ADDENDUM NUMBER 1

- 1.01 DATE: April 7, 2015
- 1.02 PROJECT: Interior Renovations to the Mimosa - G Residence
Ramapo College of New Jersey
- 1.03 SNS PROJECT NUMBER: 4698G

INTERIOR RENOVATIONS
AT THE
MIMOSA - G RESIDENCE

ENLARGED FIRST & SECOND FLOOR
PLUMBING PLANS

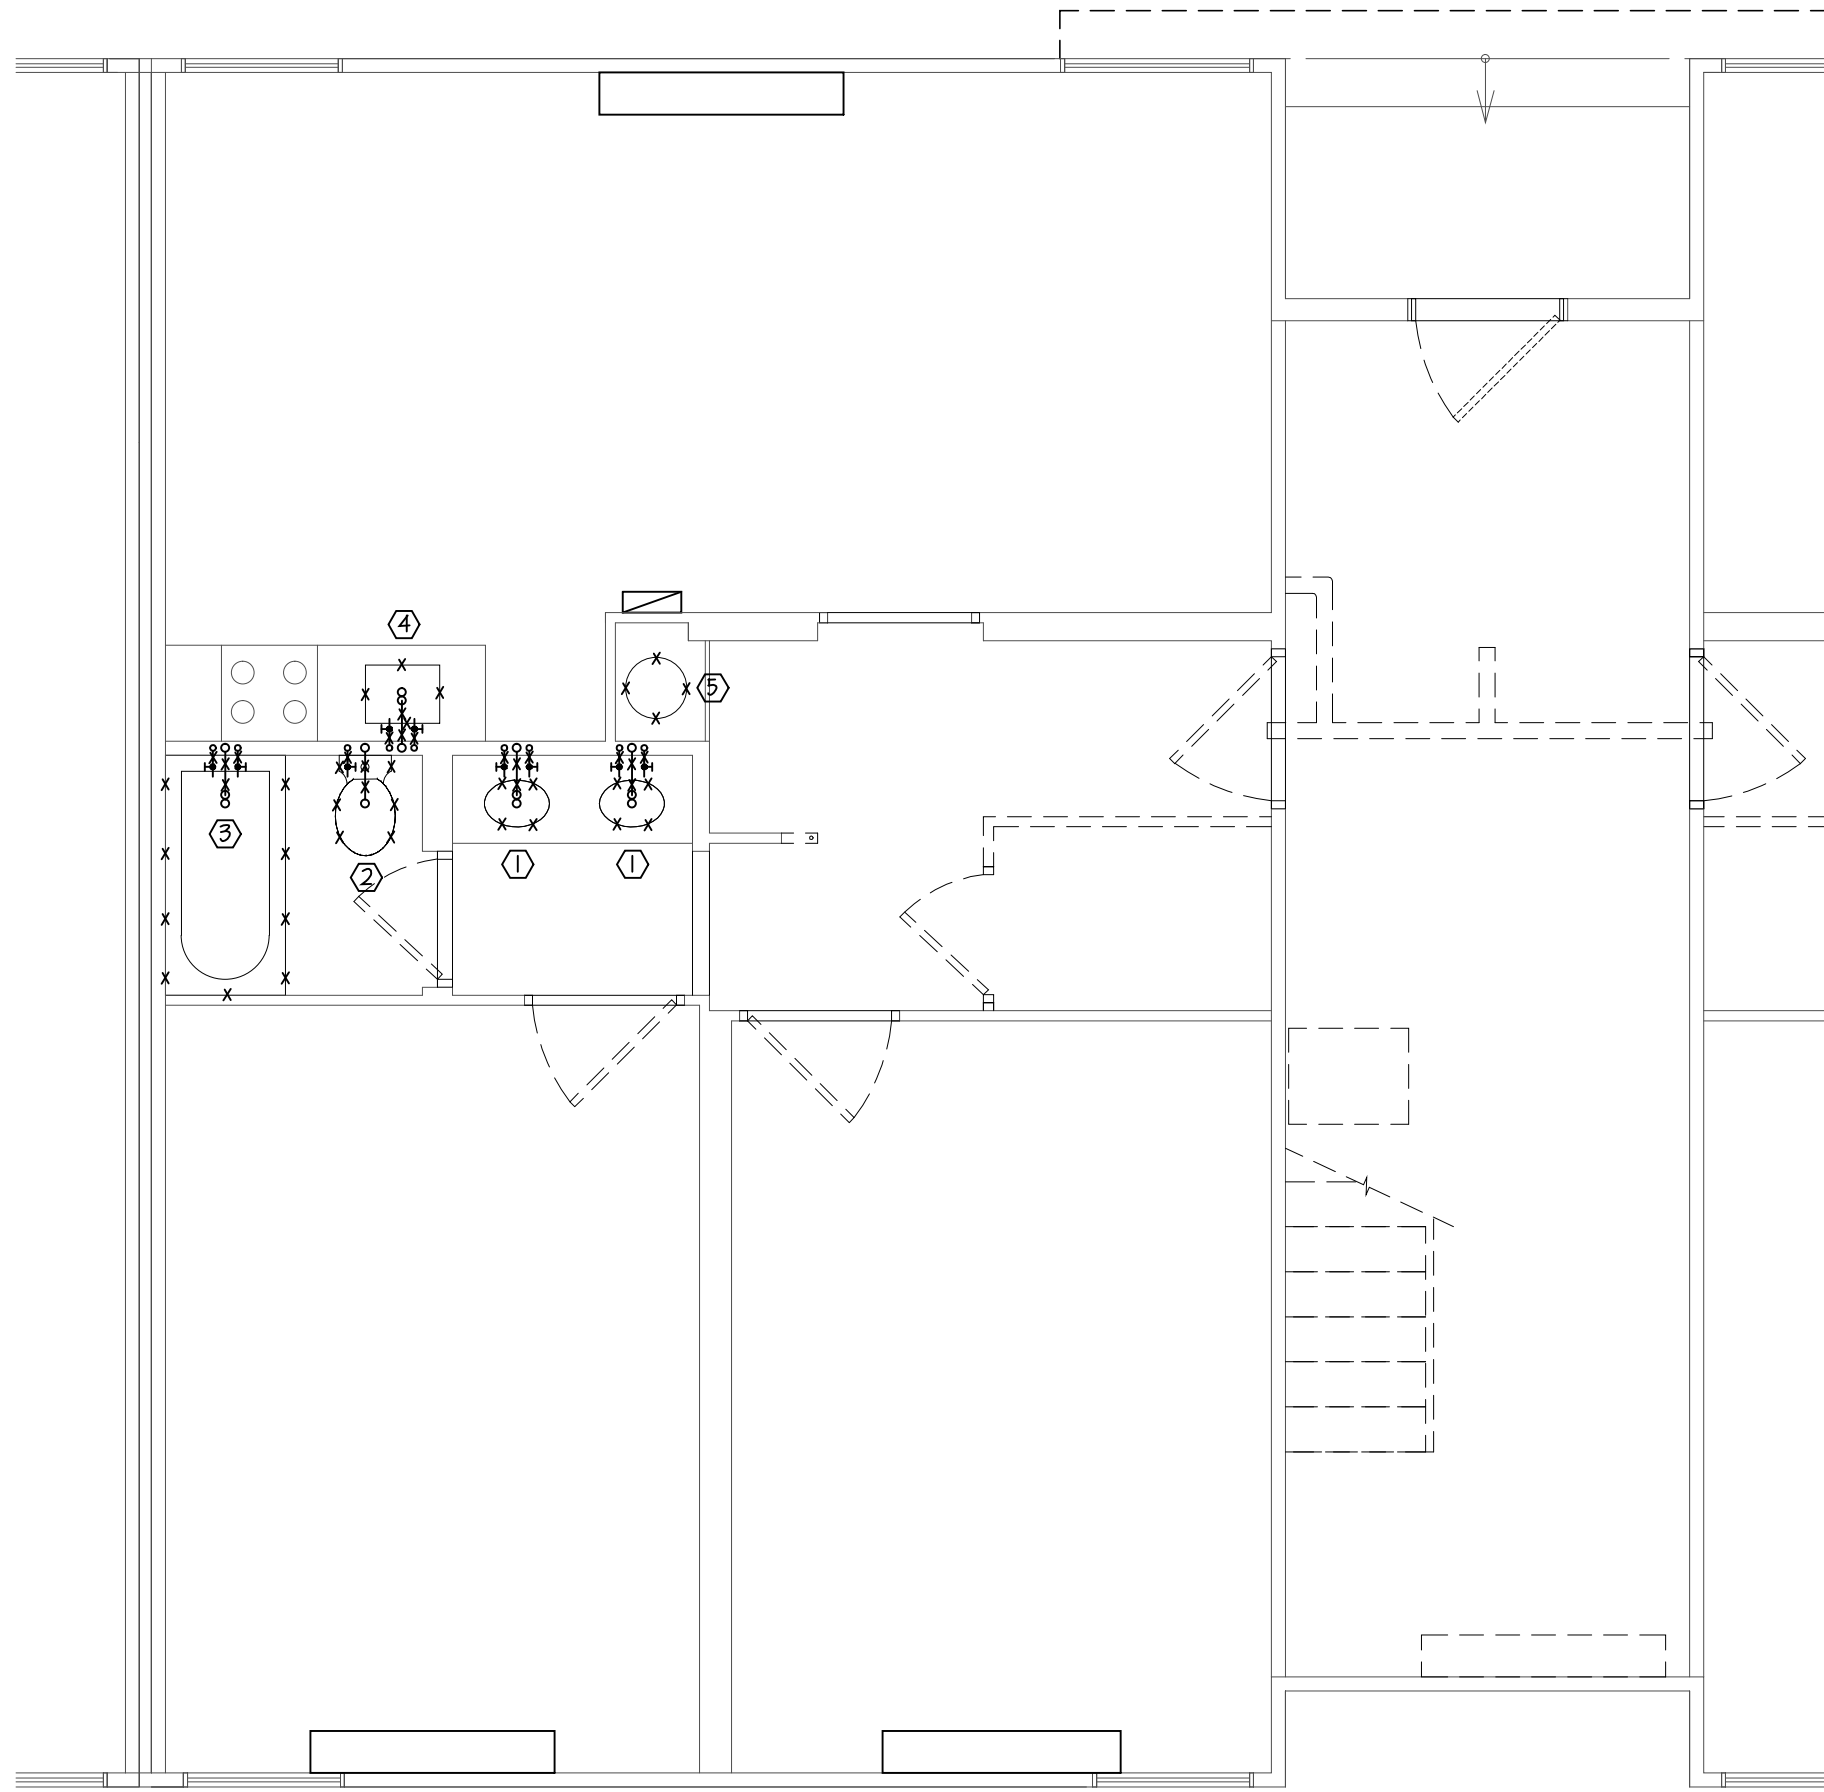
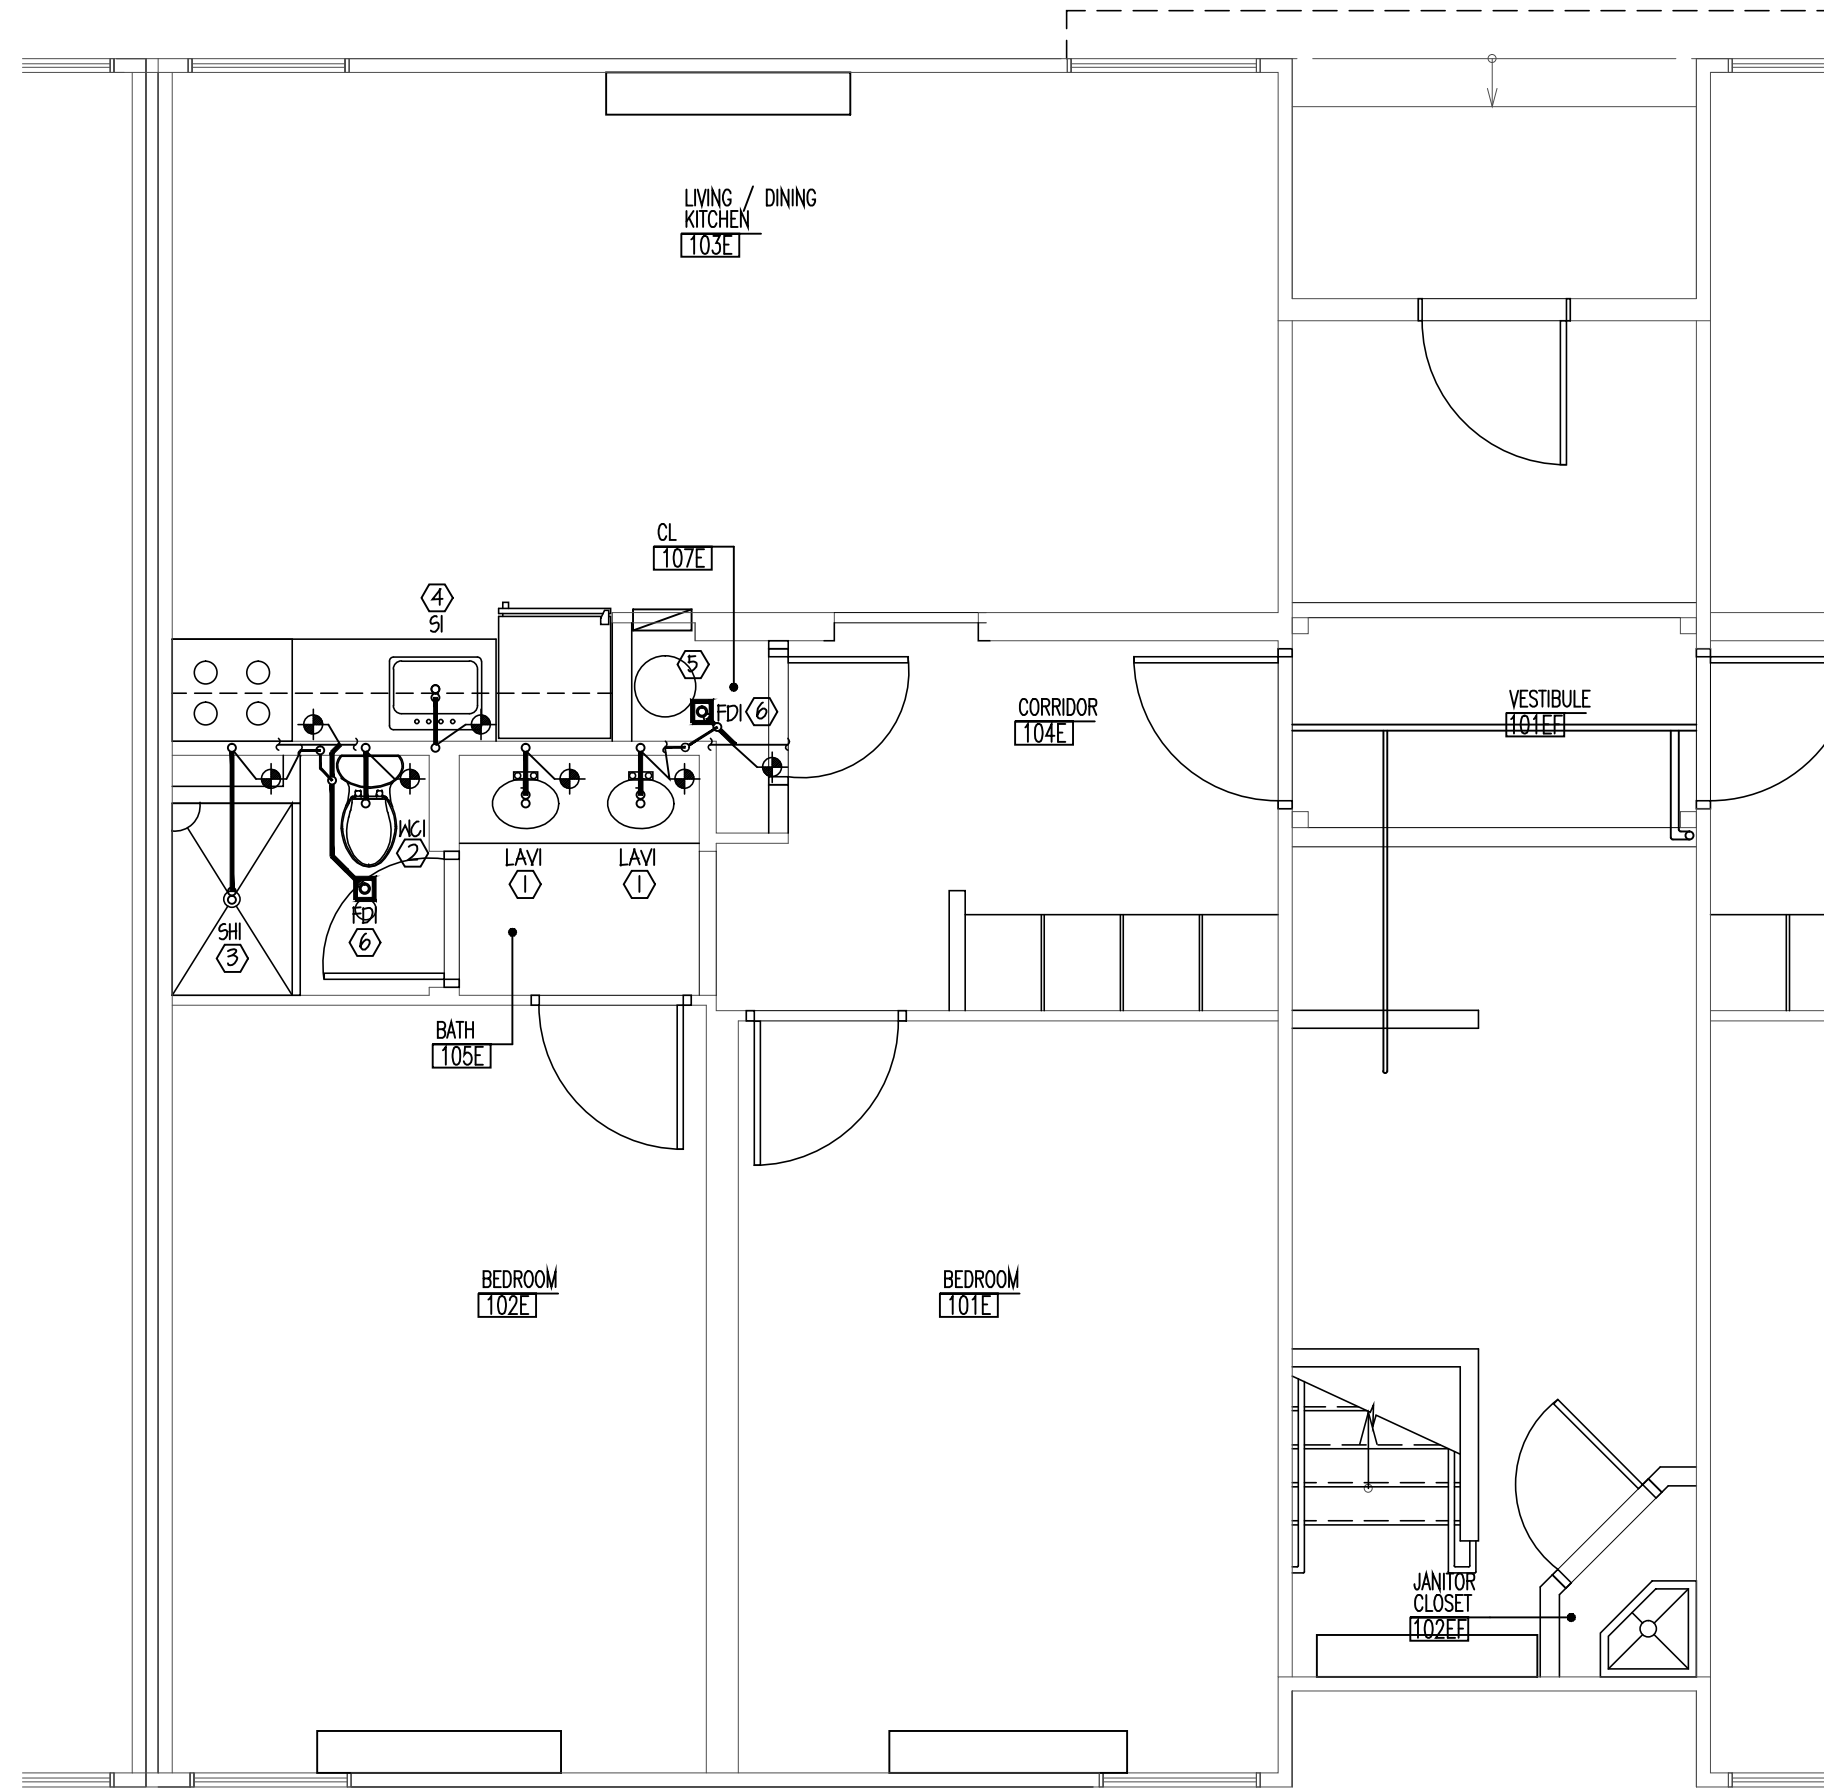
- 7.1. Added note indicating that all demolition work is by others under separate contract and filed under separate DCA permit application.
